Application of Quik Trip Corporation c/o Battle Law P.C. for a Special Land Use Permit (SLUP) to allow an alcohol outlet within a new 4,993 square foot convenience store (Quik Trip) within the C-1 (Local Commercial) District in accordance with Chapter 27, Article 4, Table 4.1 Use Table and Section 4.2.8 Supplemental Regulations of the DeKalb County Code, at Memorial Drive and Collingwood Drive.

PETITION NO: N4. SLUP-20-1244236 2020-1169

STAFF ANALYSIS

Site Plan

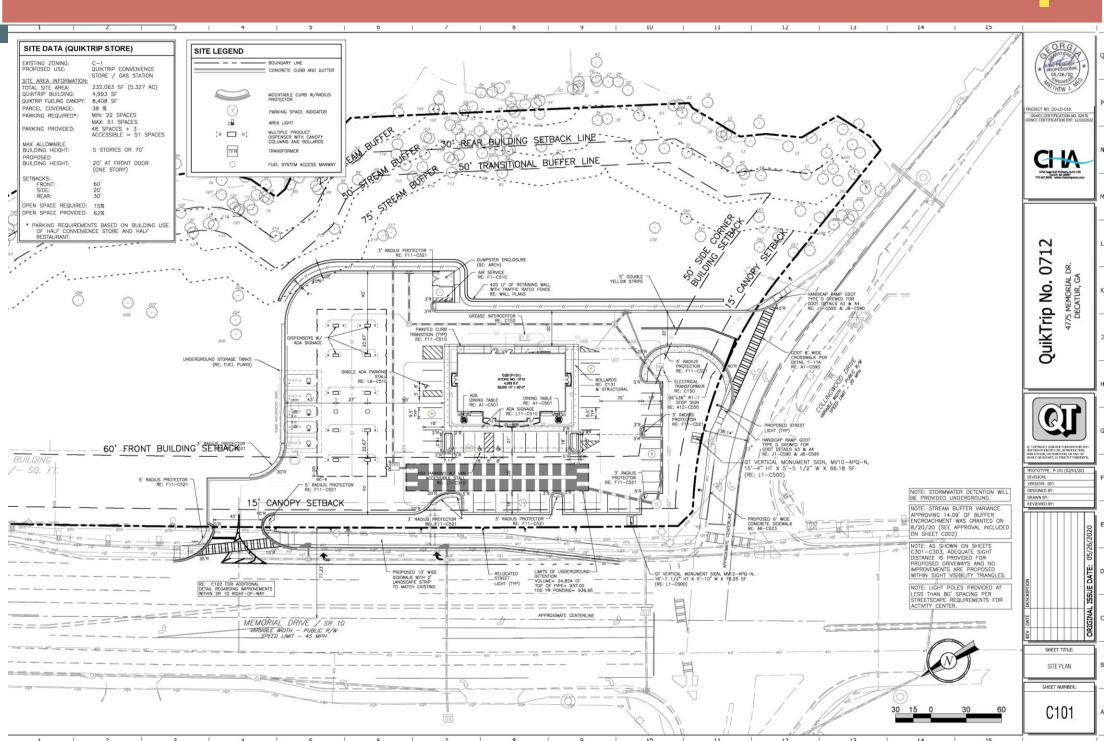
The proposed redevelopment will have adequate ingress and egress to the subject site. The proposed location will have the fuel pumps to the north side of the store which may assist with pedestrian safety by reducing vehicular/pedestrian conflicts between fuel patrons and retail patrons near store entrances. Per the applicant, the fuel trucks will access the site from Memorial drive, while the regular automotive traffic will have access from both Memorial Drive and Collingwood Drive to provide adequate circulation.

The proposed use will not create adverse impact on the adjoining land use by reason of manner of use. While there are residential properties directly to the east of the subject properties, there will be a 50-foot transitional buffer and 75-foot stream buffer (of largely existing vegetation) that separates most of the site from the residential uses to the rear of the subject property.

The submitted site plan depicts a required transitional buffer adjacent to residentially zoned properties.

- 1. Allow an alcohol outlet (beer & wine sales) in conjunction with a convenience store as depicted on the site plan, landscape plan and elevations stamped received by the Planning and Sustainability Department on September 3, 2020. The proposed site plan is conceptual and is subject to compliance with C-1 (Local Commercial) District Development standards unless variances are obtained from appropriate regulatory authorities.

- 2. Limit site to one (1) curb cut each on Memorial Drive, subject to GDOT (Georgia Department of Transportation). Limit site to one (1) curb cut on Collingwood Drive, subject to the Transportation Division of the Department of Public Works.
